Technical Memorandum

Aura P18 Signals

Project Aura P18 – Signals

Project Number P0053364

Figure 4: Proposed Separated Cycle Track Update

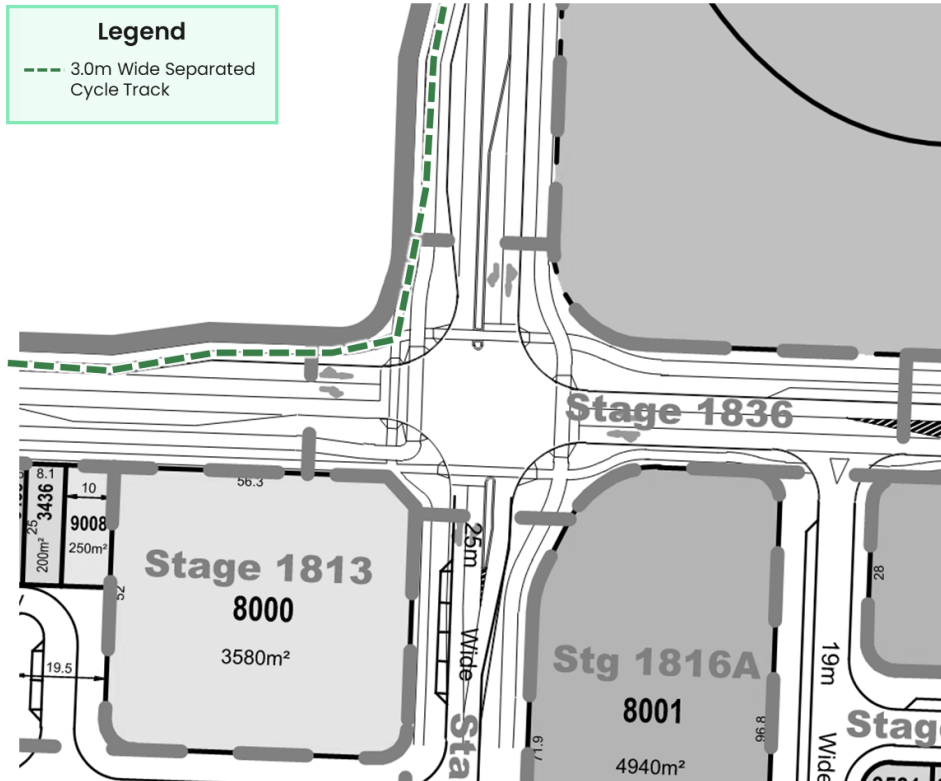
As part of wider update Aura development, Urbis has been informed that the separated cycle track is proposed to change to the northern side of the western approach, shown in Figure 4. This change will remove the current need for cyclist crossings through the intersection. **This removes the need to provide shared through-right lanes in order to provide priority phasing at the intersection.**

Therefore, the intersection should remain as per the proposed layout shown previously in Figure 4

Figure 5: EDQ Requested and Proposed Intersection Layouts

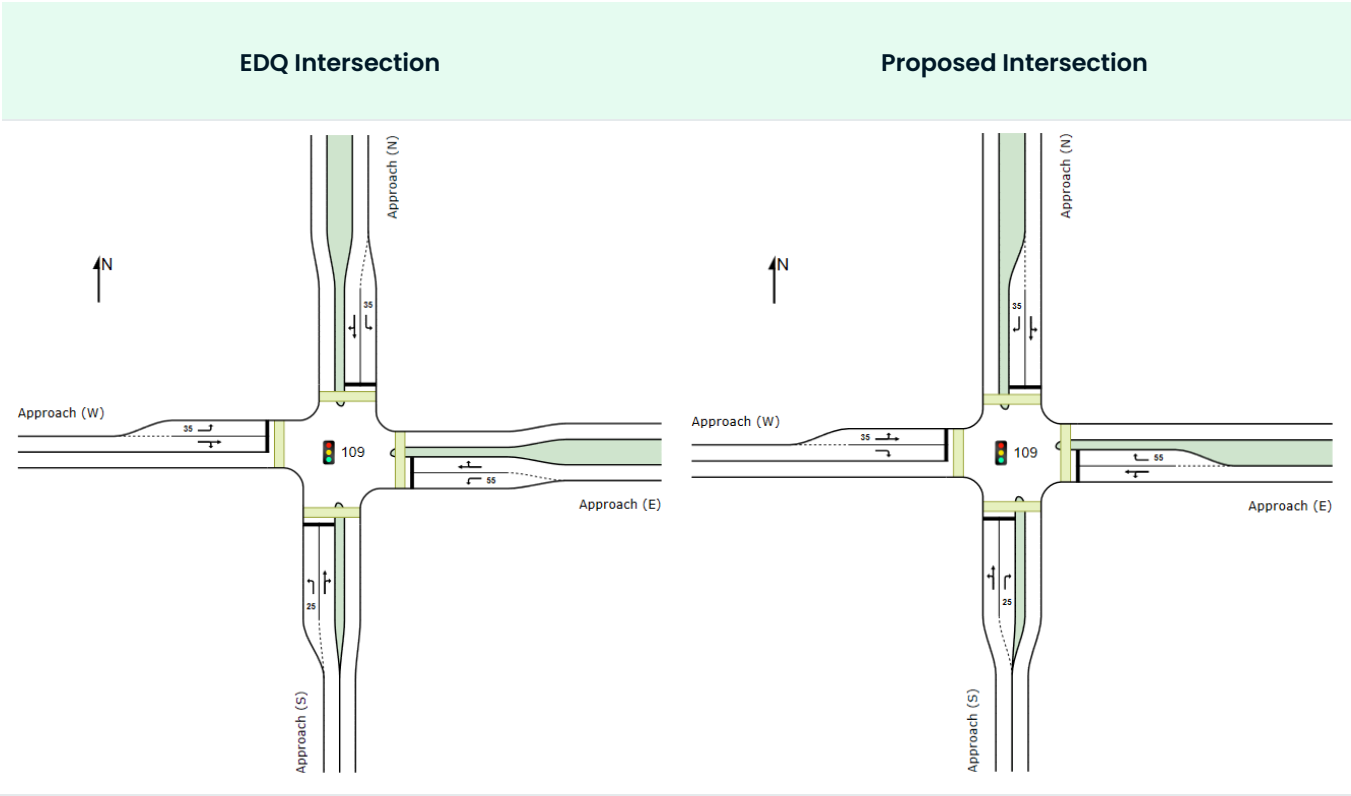
Both the requested intersection and proposed intersection layouts were assessed for the ultimate traffic scenario. The intersection layouts are shown in Figure 5. As requested, the intersection has been modelled with auxiliary left turn lanes, and shared through-right turn lanes.

The results of the SIDRA assessment for the EDQ requested and the proposed intersection layouts are shown in Table 1 and Table 4 respectively. As shown, the EDQ requested intersection exceeds practical capacity in the AM peak. The northern approach and western approaches exceed a DOS of 0.9, with maximum delays of 97.5 seconds and queue lengths of 97.9m.

For comparison, the proposed intersection layout remains within practical capacity, with a maximum DOS of 0.77. The maximum delay occurs on the northern approach with 40.4s, and a queue length of 61.5m.

As such, it is recommended to maintain the approved through-left movement lane design for the intersection as shown in Figure 1.
